SUBJECT: COMANCHE PEAK STEAM ELECTRIC STATION
DOCKET NOS. 50-445 AND 50-446
SUPPLEMENT TO LICENSE AMENDMENT REQUEST (LAR) 07-004
REVISION TO THE OPERATING LICENSE AND TECHNICAL SPECIFICATION 1.0, "USE AND APPLICATION" TO REVISE RATED THERMAL POWER FROM 3458 MWT TO 3612 MWT. (TAC NOS. MD6615, MD6616, MD8417 AND MD8418)

RESPONSE TO REQUEST FOR ADDITIONAL INFORMATION
COMANCHE PEAK STEAM ELECTRIC STATION STRETCH POWER UPRATE

HELB COMPARISON

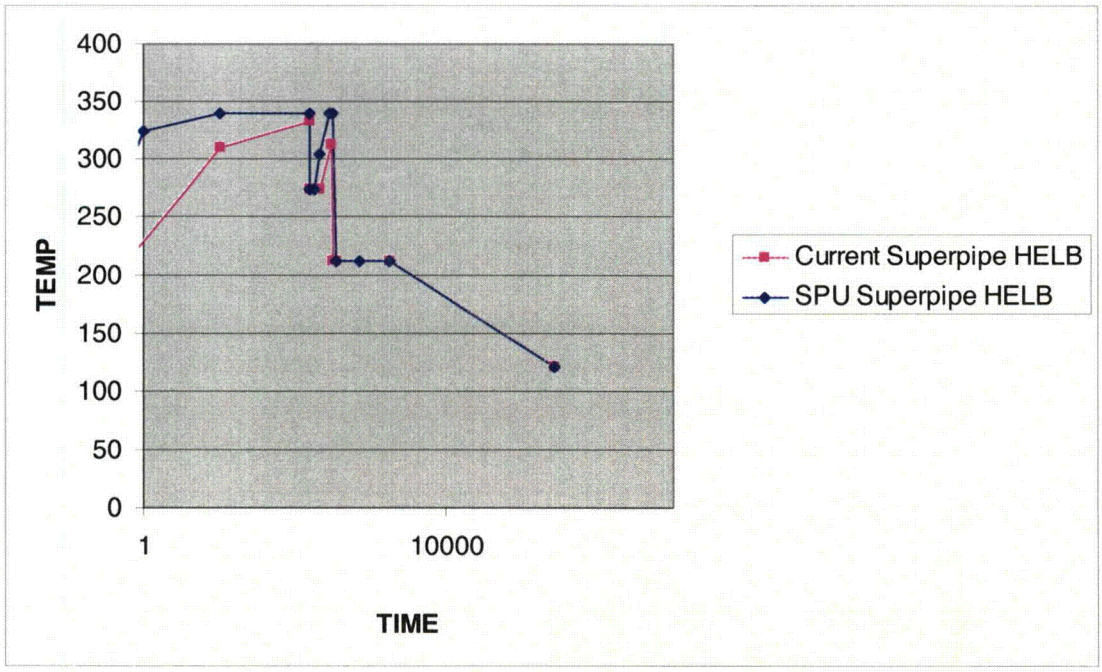
The following is a comparison of the current HELB profile and the SPU HELB profile for superpipe areas.

The new SPU superpipe HELB has a faster rise time than the previous temperature profile. The peak temperature of the SPU profile is 340°F. The profile is at the peak temperature for a total of 175 seconds, when the time at this temperature for both peaks is considered. The peak temperature in the previous profile was approximately 334°F, and this peak temperature was only achieved during the first temperature spike.

After 350 seconds the profiles are the same. The profiles are shown for 72.5 hours.

Figure 1

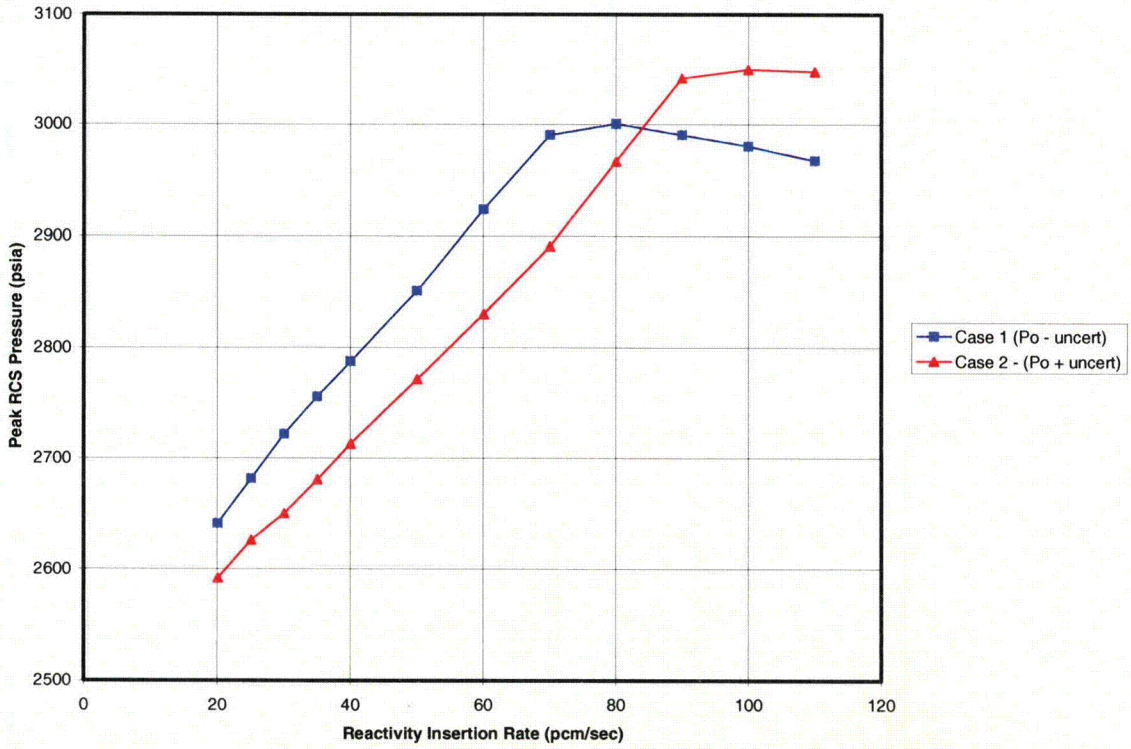
2. Transient plots for the limiting pressurization case resulting in excessive reactor coolant system (RCS) pressurization.

Figure 1 shows trends of the calculated peak RCS pressure results versus reactivity insertion rate for the two generic cases that resulted in the maximum RCS pressures without taking credit for the PFRT. Case 1 assumes the minimum initial pressurizer pressure of 2200 psia, while Case 2 assumes the maximum initial pressurizer pressure of 2300 psia. What is important to observe in Figure 1 is that although the high pressurizer pressure reactor trip can be actuated in time to protect against exceeding the RCS pressure limit (2748.2 psia) for lower reactivity insertion rates, it is insufficient for higher reactivity insertion rates. For low reactivity insertion rates, the nuclear power and RCS temperature increase relatively slowly, such that the main steam safety valves (MSSVs) are able to open and limit the primary-to-secondary power mismatch until the reactor trip is actuated. At greater reactivity insertion rates, the reactor power begins increasing faster than the primary system can transfer the heat to the secondary,

and the power mismatch continues to increase until the reactor trip occurs and the control rods insert into the core. Without the PFRT, the maximum reactivity insertion rate would need to be limited to a fairly low value.
